### Inspection Report Minerals Regulatory Program

<b>Mine Name:</b> Jumbo-Jensen Quarry	<b>Permit Number:</b> M/041/0008
<b>Operator Name:</b> United States Gypsum Company	<b>Inspection Date:</b> March 31, 2011
<b>Inspector(s):</b> Peter Brinton, Paul Baker	<b>Time:</b> 10:00am to 3:00pm
<b>Other Participants:</b> Jeremy Taylor & Bruce Allen, US Gypsum	<b>Mine Status:</b> Active

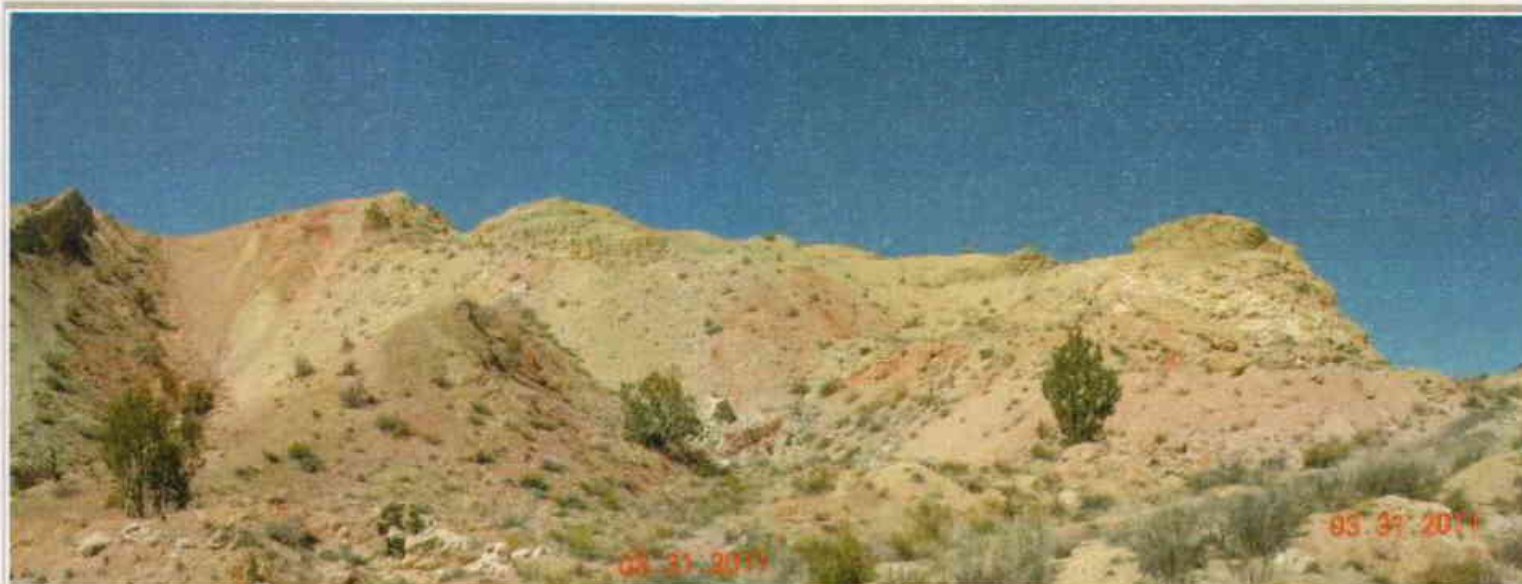
Steep pre-law slope with vegetative cover comparable to some natural steep and south-facing slopes.
